TENANT IMPROVEMENT PLAN CHECK COMMENTS

PLAN CHECK NO:	10174128		
PROJECT ADDRESS:	5 E Hutton Center Dr Unit# 1050		
PLAN CHECK ENGINEER:	Ahangian, Kathy	TEL: 714	647-5812
		FAX: 714	647-5897
TYPE OF CONSTRUCTION:	I A, SPK		
OCCUPANCY CLASSIFICATION(S):	B		
PLAN CHECK DATES:	REMARKS/RECHECK ITEMS:		
APPLICATION	2/8/2012	_____	
INITIAL REVIEW	2/18/2012	_____	
EXPIRATION	8/6/2012	_____	
RECHECKS:	1. 2-28-12	PROJECT APPLICANT CONTACT PERSON:	
	2. 2-29-12	Judy or Mark Yam	
	3.	TEL:	(626)675-9882
VALUATION:	\$149,500.00	FAX:	_____
FLOOD ZONE:	X-0602320278J	EMAIL:	meiyeeyam@sbcglobal.net

Project Name
MICHAEL F MORAN
4,185 R.S.F.

MICHAEL F MORAN
5 HUTTON CENTRE DRIVE
SUITE 1050
SANTA ANA, CA 92707

Description
10TH FLOOR
CONSTRUCTION PLAN & DOOR SCHEDULE

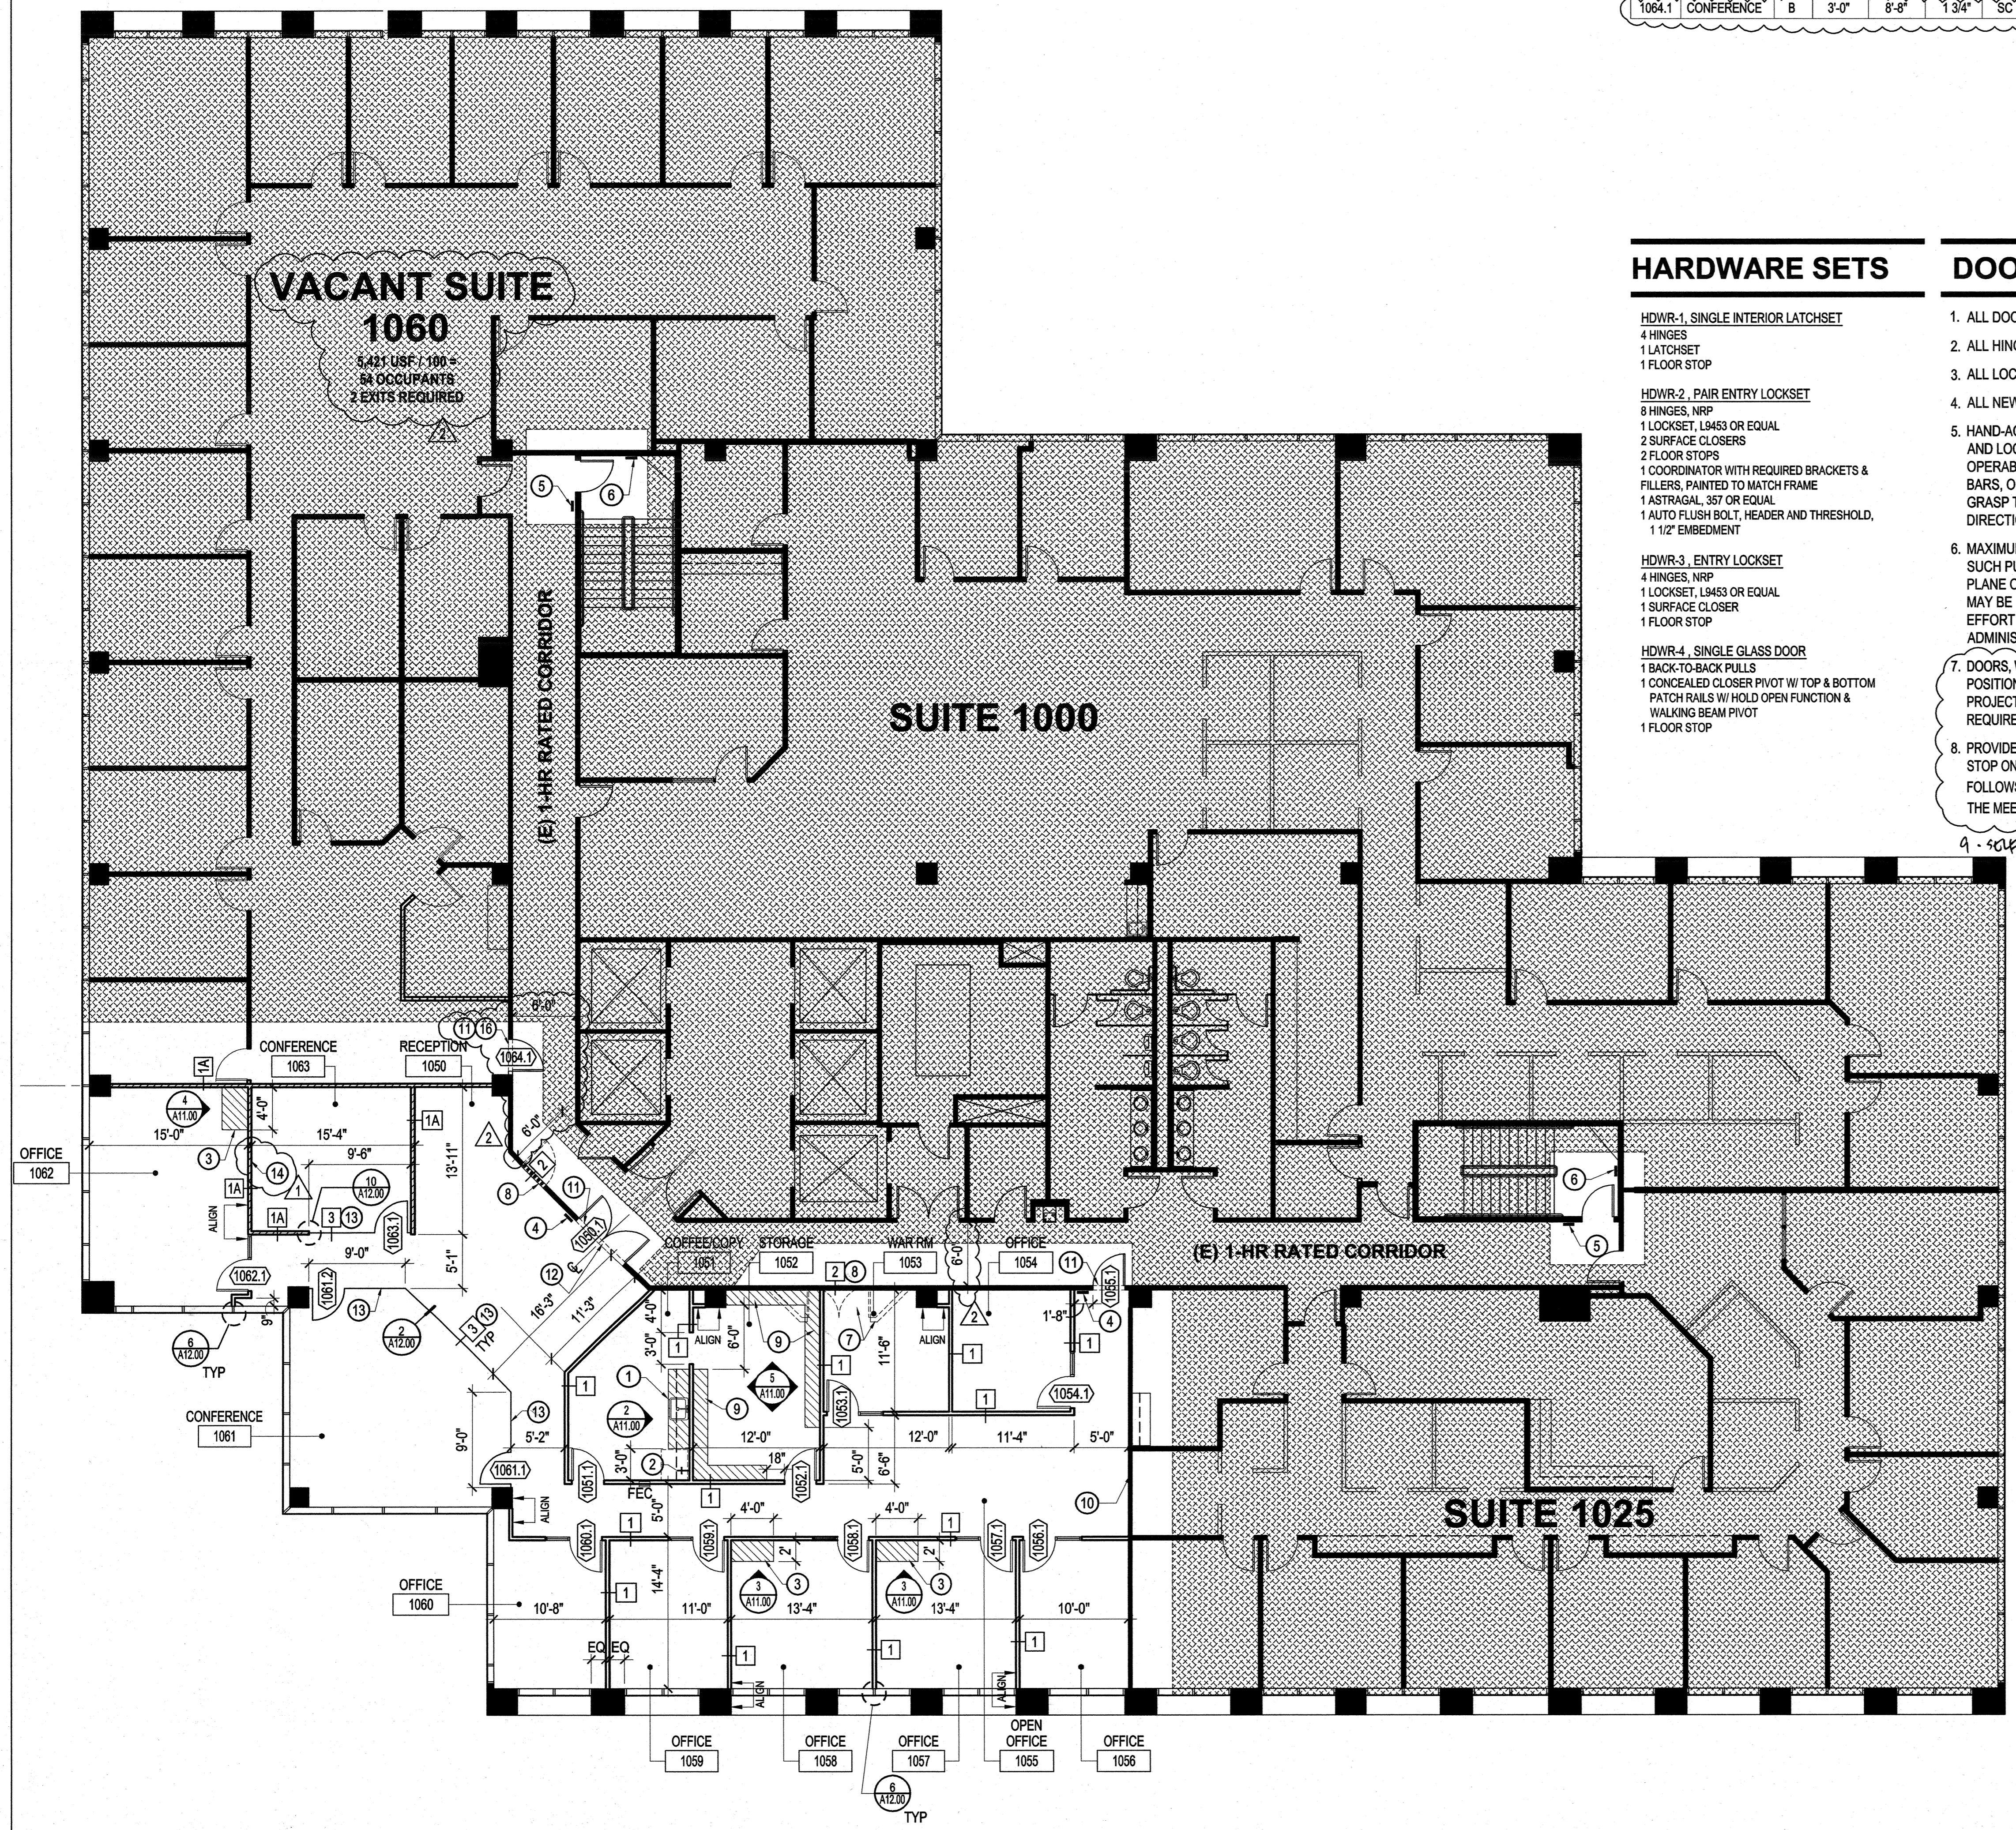
9. Provide complying exiting plan for the "reminder" area. Note the use of adjacent units. *See sheet A02-10*

10. Provide sf of the adjacent suite. *See sheet A2-10*

11. Provide number of exits required by CBC Sections 1015 and 1016. (For adjacent suite) *see sheet A02-10*

13. Note on the drawings CBC Section 715 requirements for a pair of doors installed in a one-hour corridor wall. Door is 20min rated. See door schedule on sheet A2.10.

14. CBC Section 1024.5.1. Doors, when fully opened, and handrails shall not reduce the required width by more than 7". Doors in any position shall not reduce the required width by more than one-half. Other nonstructural projections such as trim and similar decorative features are permitted to project into the required width 1.5" from each side. (For door # 1055.1) See door note #7 on sheet A02.10

20. Show width of the corridor. Width added. See sheet A02.10.

See door note #9 on sheet A2.10

EXIST. SUSPENDED TILE CEILING
 SCALE: 1/16"=1'-0" CL01 20

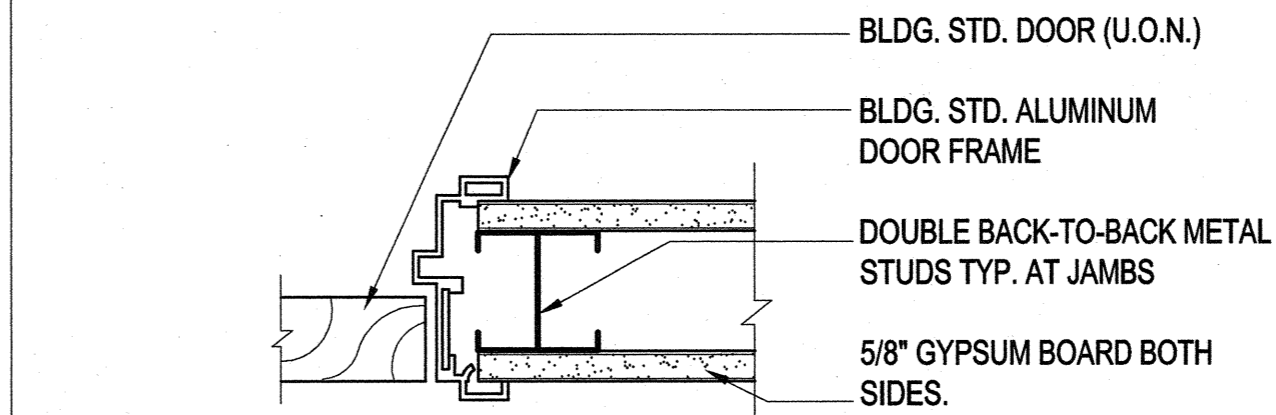
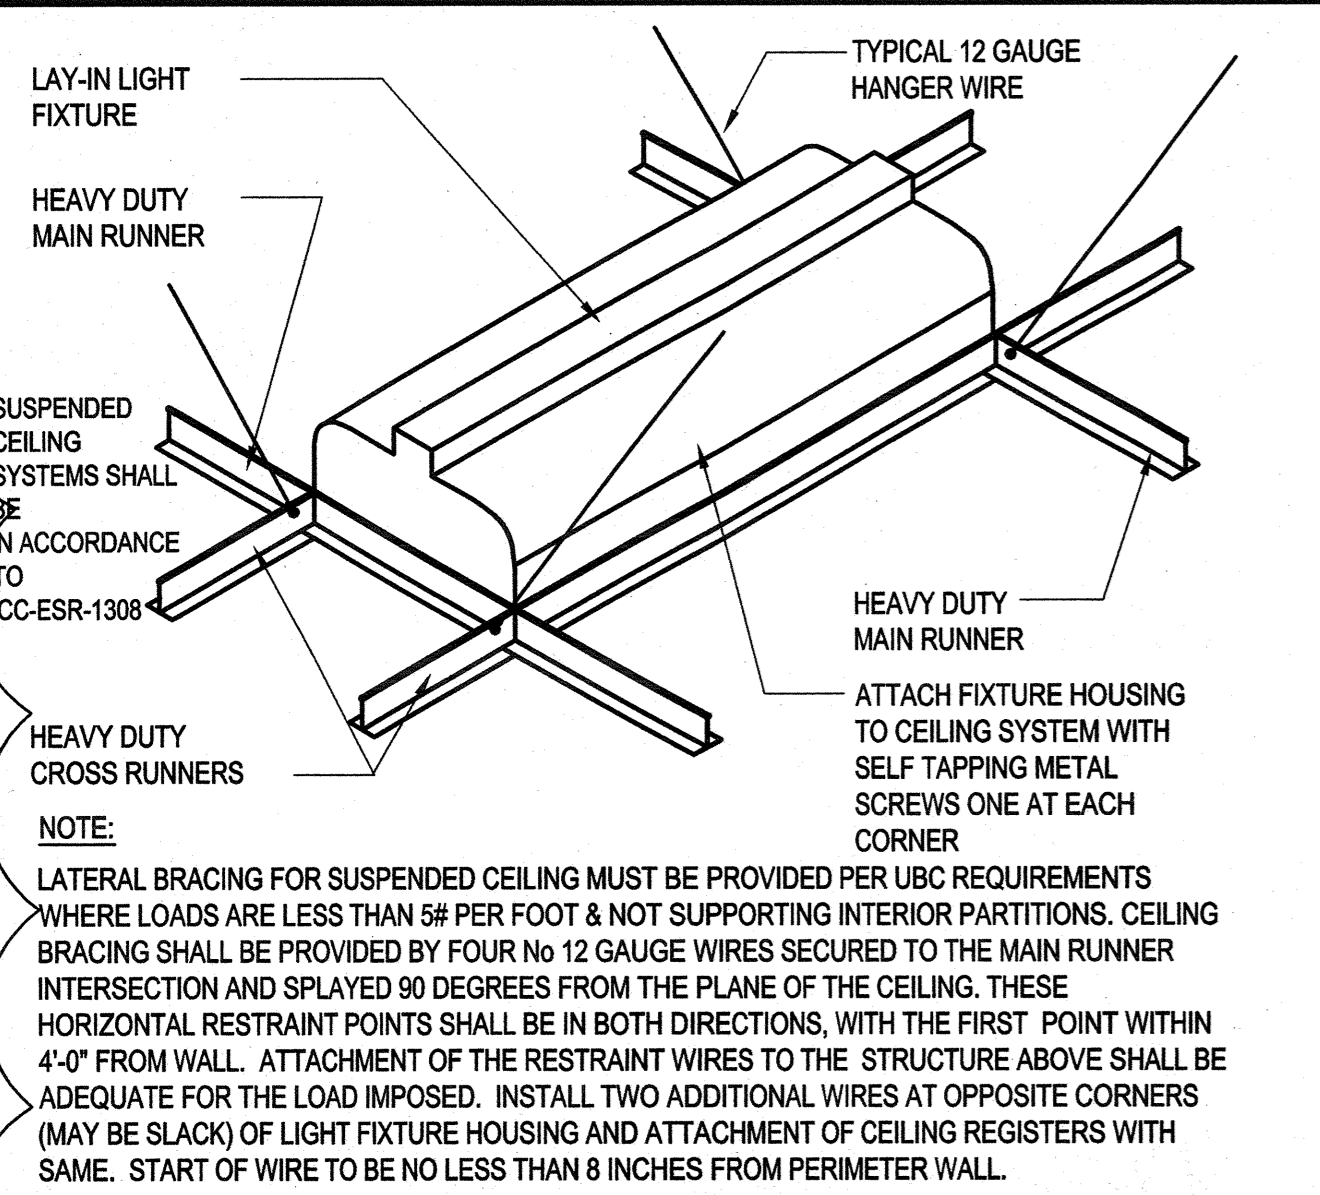
21. Provide complete structural calculations and drawings for suspended ceiling systems showing compliance with CBC Sections 711.3.1, 803.9, 1613, and 1705 (special inspections) and ASTM C635 and ASTM C636. (OR See Comment #22 to #24) See sheet A12.00

22. Provide a complete suspended ceiling system plan and section detail showing the following:

23. The reflected ceiling plan and details must show compliance with CBC Sections 711.3.1, 803, 1613, and 1705 (special inspection) for suspended ceiling systems. See sheet A12.00

24. Note ICC Research Report Number on the drawings for the suspended ceiling system. (ICC Report Number 1308) See sheet A12.00

WALL FRAMING CHART
 SCALE: NONE DT_WA-STUDCHART 17

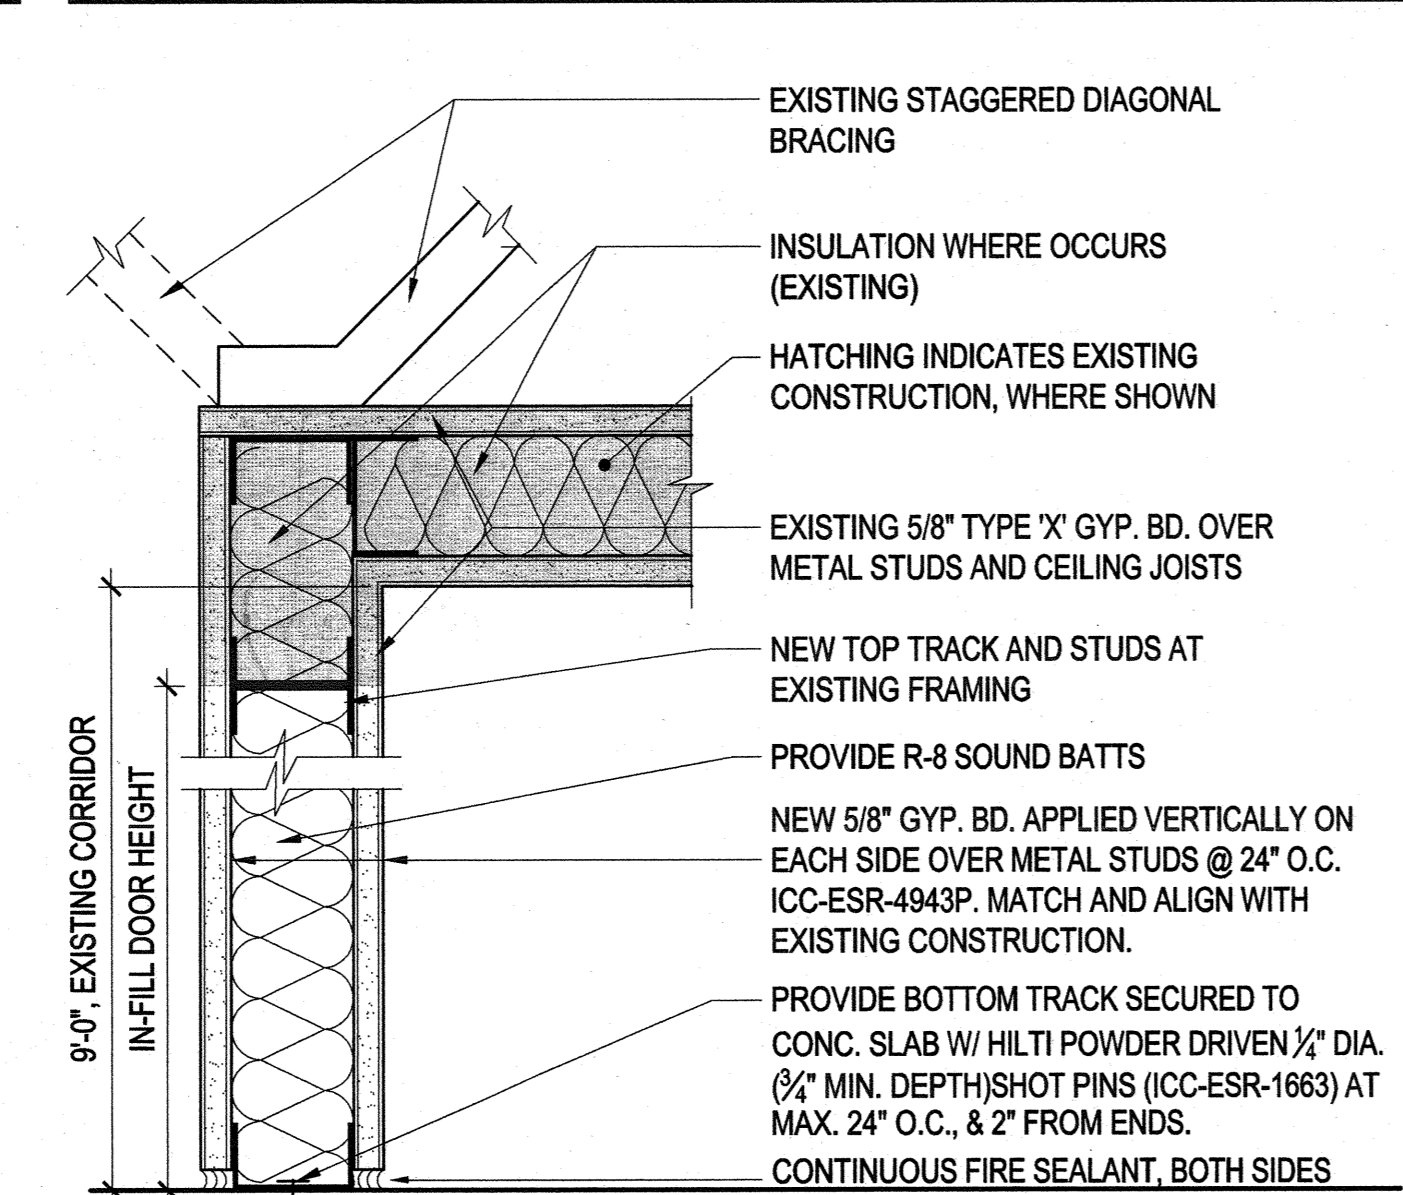
16. Provide span table for metal studs. Span table added on sheet A12.00

IN-FILL AT RATED CORRIDOR
 SCALE: 3"=1'-0" WA06_J2 4 15

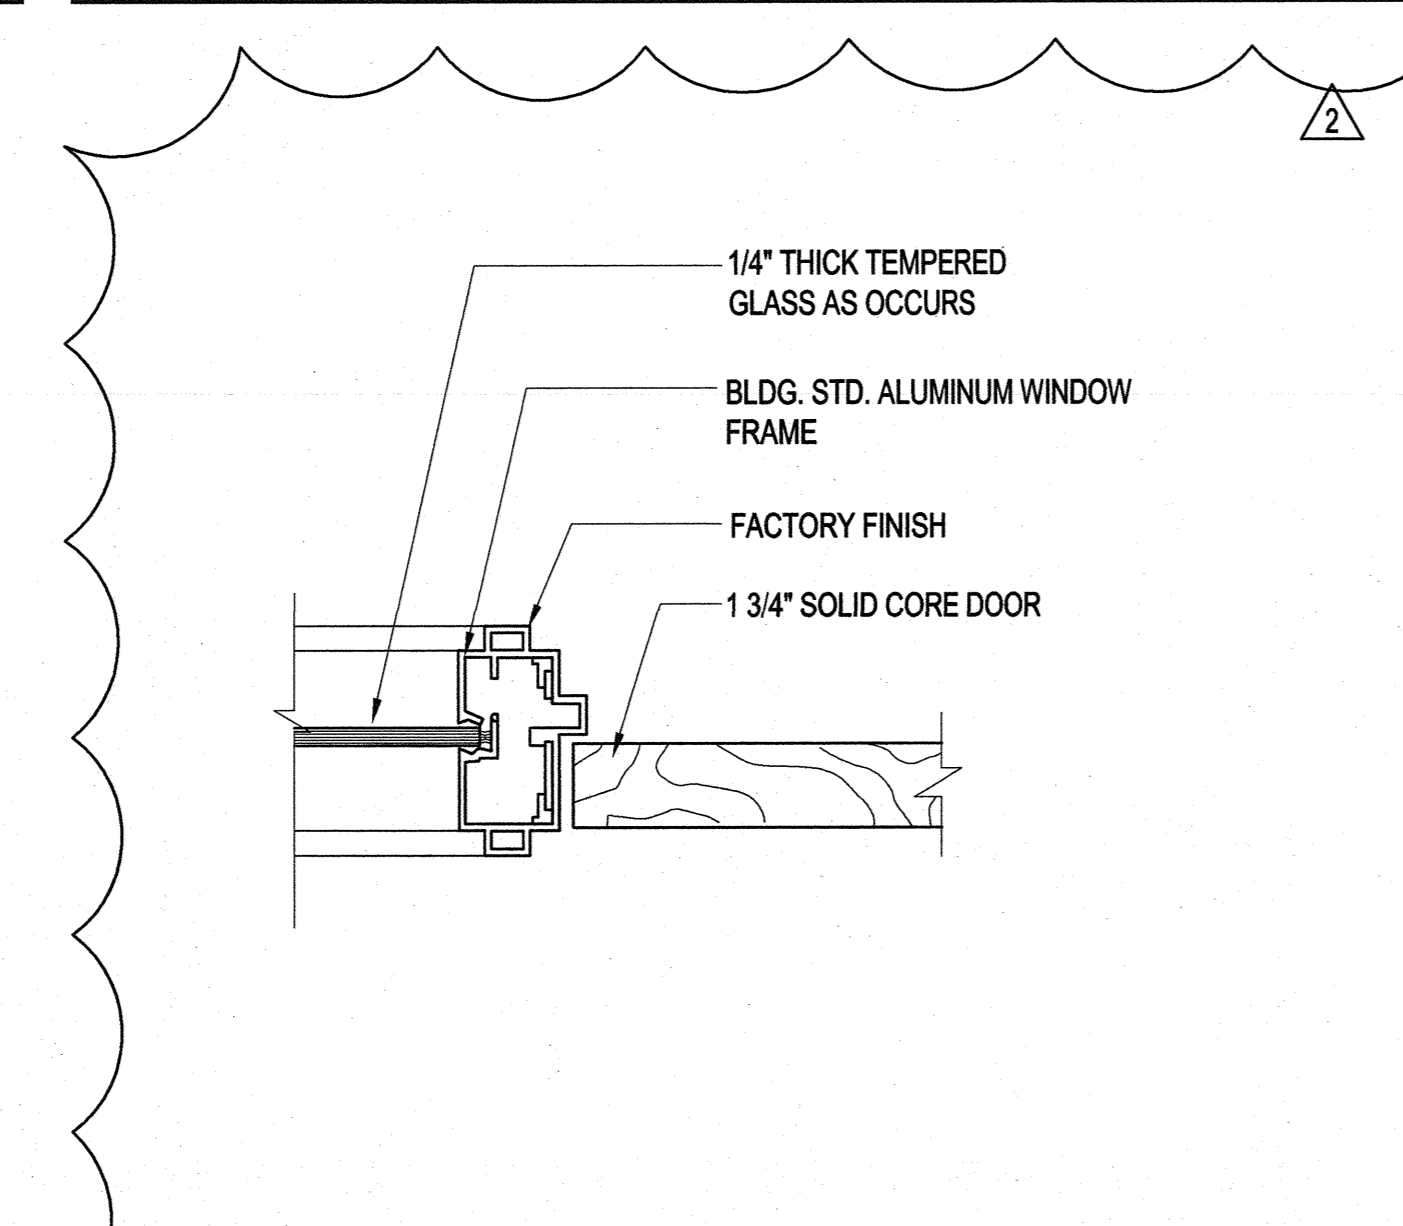
12. **Provide typical complete section view through one-hour corridor(s) showing compliance with CBC Sections 1017 and 708:** *see detail 15/A12-00.*
